Office Action Summary	Application No. 10/605,663	Applicant(s) LANE, RONALD S.	
	Examiner Gwendolyn Baxter	Art Unit 3632

This is the third office action for application serial no. 10/605,663, Bookstand that Folds Thin Enough to serve as a Bookmark filed October 16, 2003.

DIAGRAM 3

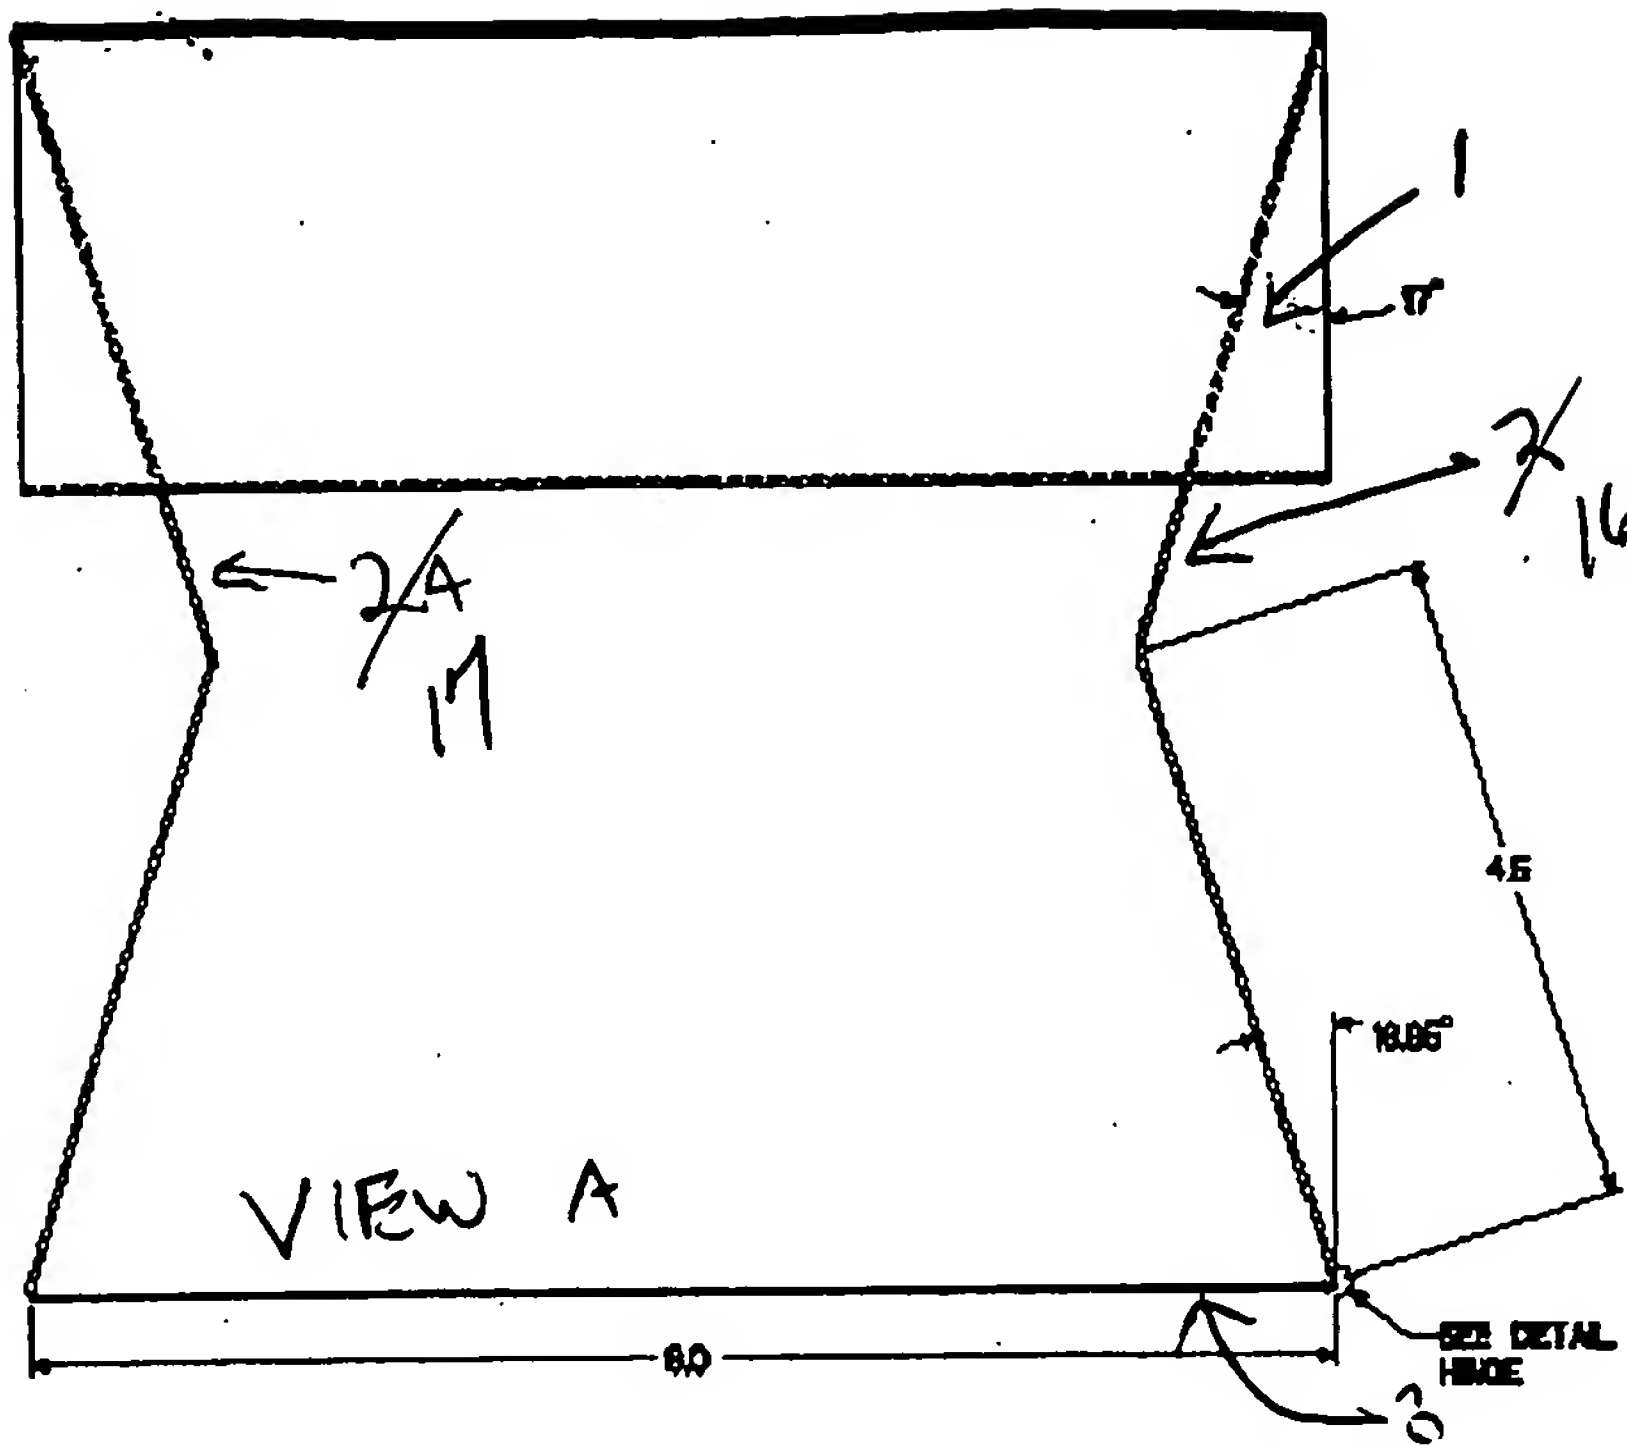
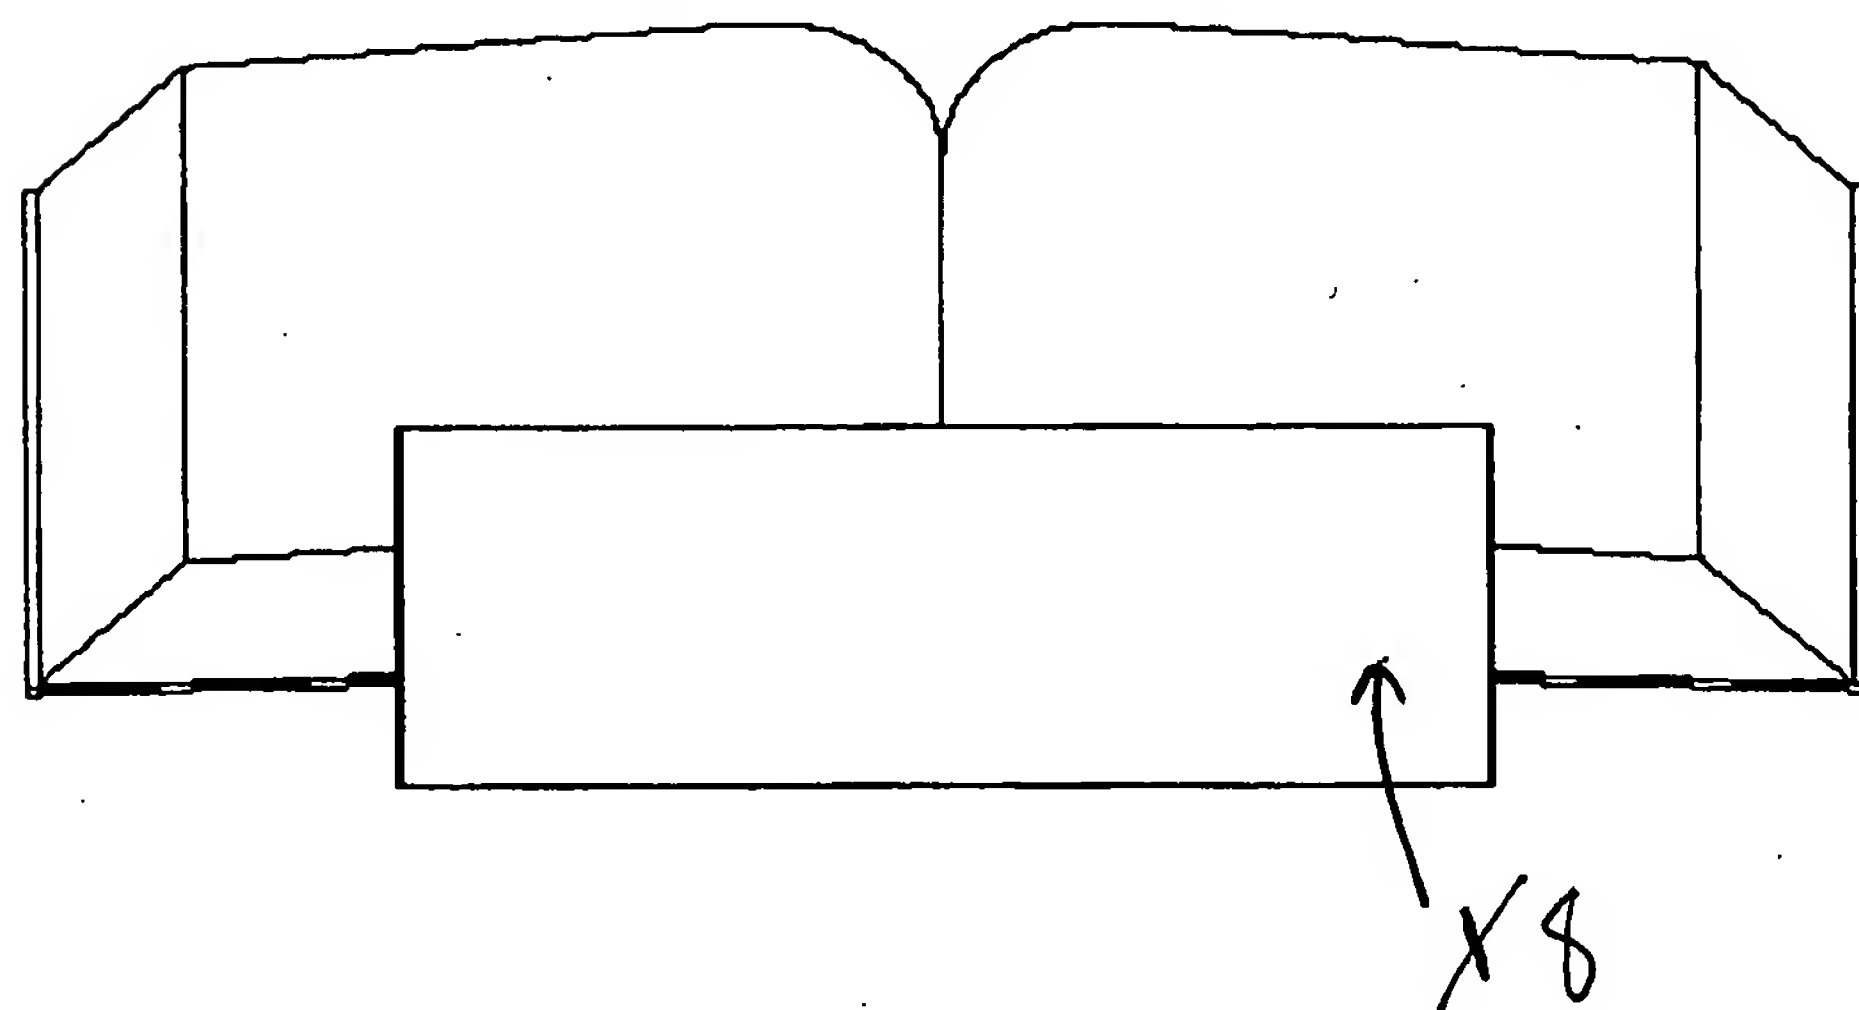
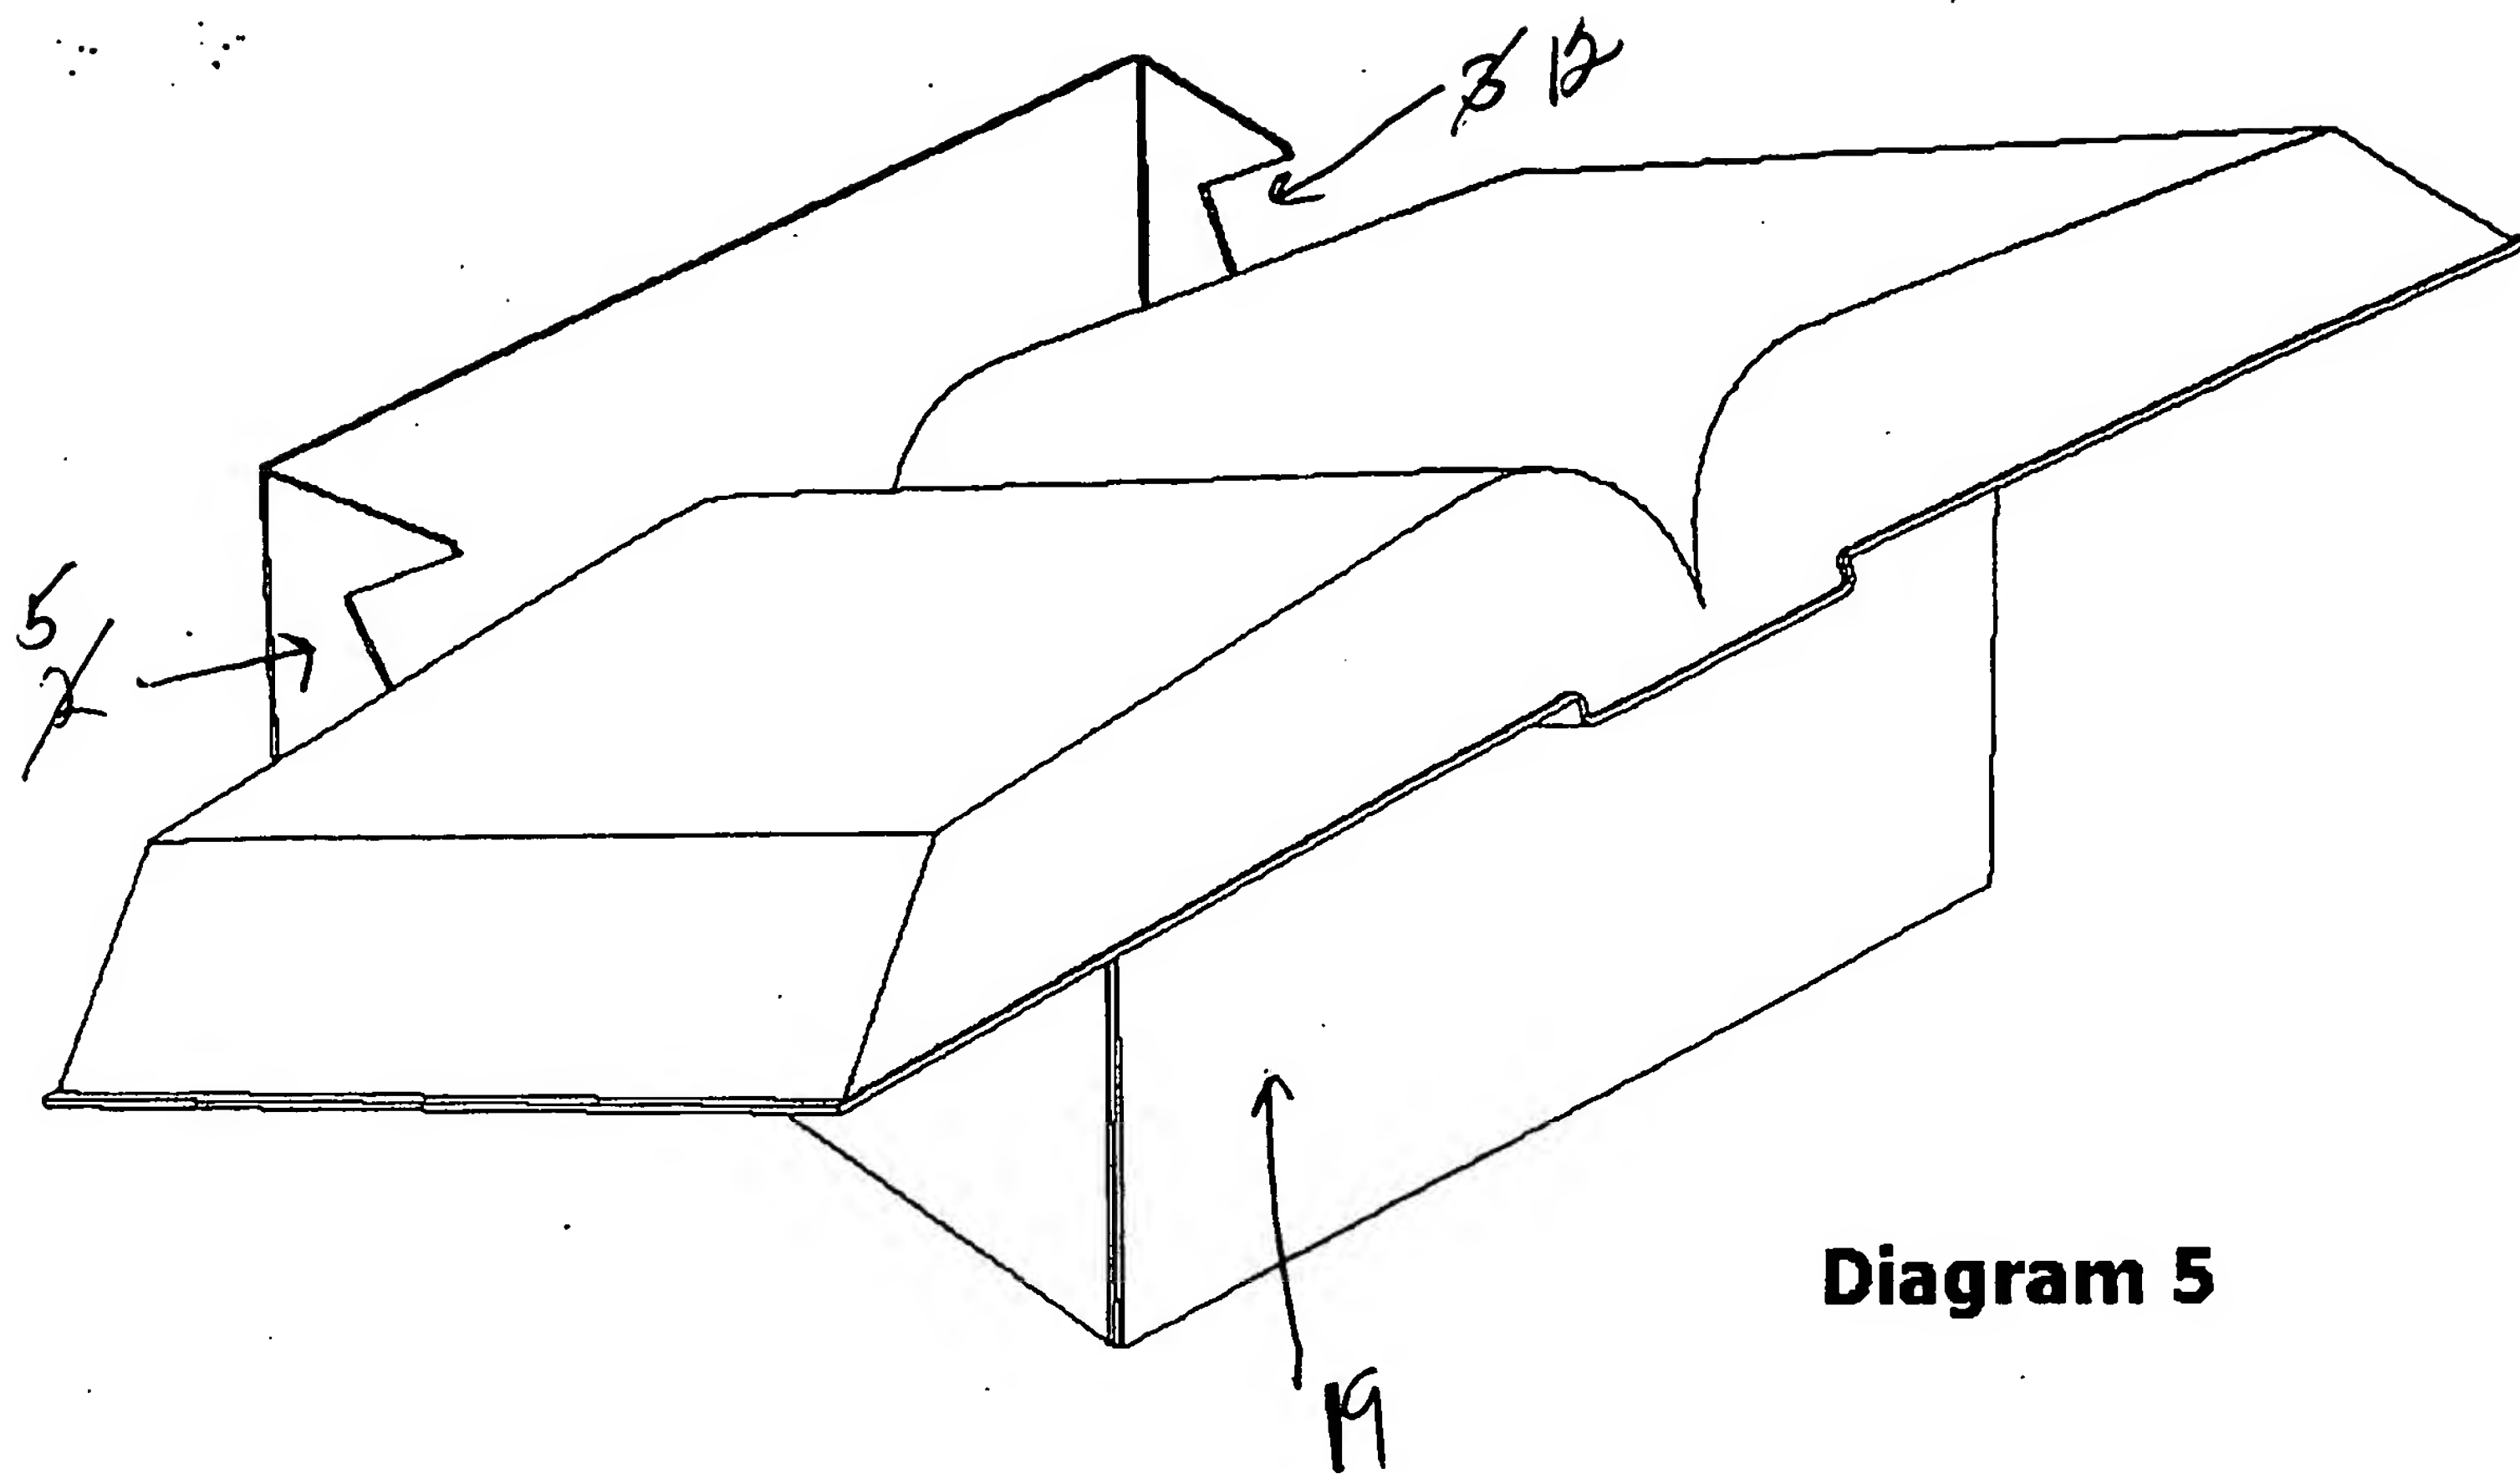
In order to reconcile the reference numerals in the specification and drawings, the following suggestions are made to correct different parts with the same reference numerals and/or different numbers for the same part. See modified copy of the drawing supplied by the examiner.

Corrected drawing sheets in compliance with 37 CFR 1.121(d) are required in reply to the Office action to avoid abandonment of the application. Any amended replacement drawing sheet should include all of the figures appearing on the immediate prior version of the sheet, even if only one figure is being amended. Each drawing sheet submitted after the filing date of an application must be labeled in the top margin as either "Replacement Sheet" or "New Sheet" pursuant to 37 CFR 1.121(d). If the changes are not accepted by the examiner, the applicant will be notified and informed of any required corrective action in the next Office action. The objection to the drawings will not be held in abeyance.
